NRC DOCKET NUMBERS 50-424 AND 50-425
CONSTRUCTION PERMIT NUMBERS CPPR-108 AND CPPR-109
VOGTLE ELECTRIC GENERATING PLANT
CONTROLS FOR FIELD CHANGE NOTICES

Georgia Power Company (GPC) has evaluated the concerns delineated in the NRC's letter of September 20, 1982, from B.J. Youngblood to D.E. Dutton, concerning the Field Change Notice (FCN) program and its related controls instituted at the Vogtle Electric Generating Plant. The attachment to this letter provides specific responses to the additional information requested in your letter.

The organization chart for the above Construction personnel is attached for your information.

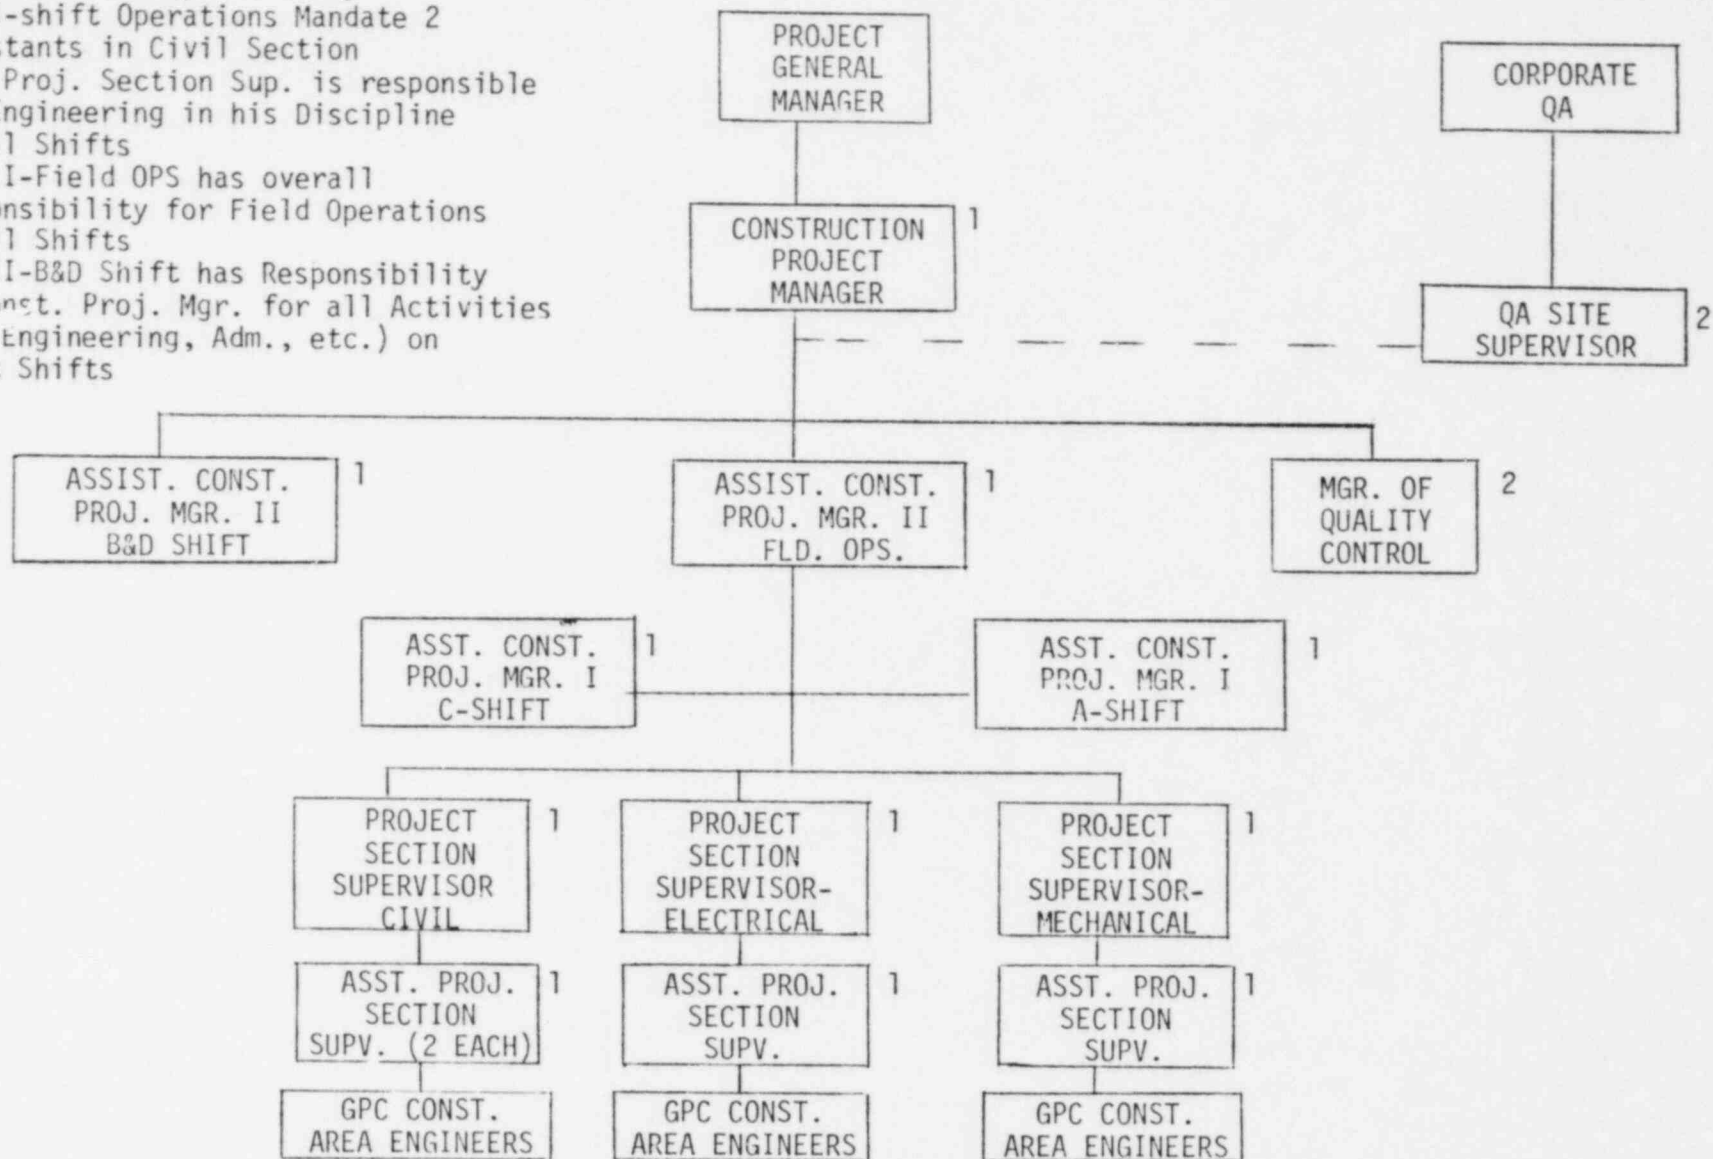
260.5 Describe the GPC organizational arrangement at the site including the position, responsibilities, and authority of the individuals authorized to approve FCNs, i.e., Assistant Project Section Supervisor level or above. Describe the extent that these individuals are isolated from the pressures of construction schedules and cost.

The approval authority of FCNs rest with the following twelve personnel:

- Construction Project Manager (CPM)
- Assistant Construction Manager II (ACPMII) -
Field Operations
- Assistant Construction Manager II (ACPMII) -
"B" and "D" Shift Operations
- Assistant Construction Manager I (ACPMI) -
"A" Shift Operations
- Assistant Construction Manager I (ACPMI) -
"C" Shift Operations
- Project Section Supervisor (PSS) - Mechanical
- Project Section Supervisor (PSS) - Electrical
- Project Section Supervisor (PSS) - Civil
- Assistant Project Section Supervisor (APSS) -
Mechanical
- Assistant Project Section Supervisor (APSS) -
Electrical
- Assistant Project Section Supervisor (APSS) -
Civil (two each)

All of the above twelve supervisory personnel are directly responsible for contractor Cost/Schedule performance and as such are not isolated from construction schedules and cost pressures. Although these people are not isolated from the cost and schedule pressures, they insure that the latest approved drawings, specifications, and procedures are available and being used for construction. They also perform surveillance of work in progress to insure that established procedures are producing quality work.

- 1-FCN Approval Authority
- 2-Review/Audit Responsibility
- 3-Multi-shift Operations Mandate 2
Assistants in Civil Section
- 4-Each Proj. Section Sup. is responsible
for Engineering in his Discipline
on all Shifts
- 5-ACPMII-Field OPS has overall
Responsibility for Field Operations
on all Shifts
- 6-ACPMIII-B&D Shift has Responsibility
to Const. Proj. Mgr. for all Activities
(QC, Engineering, Adm., etc.) on
Night Shifts
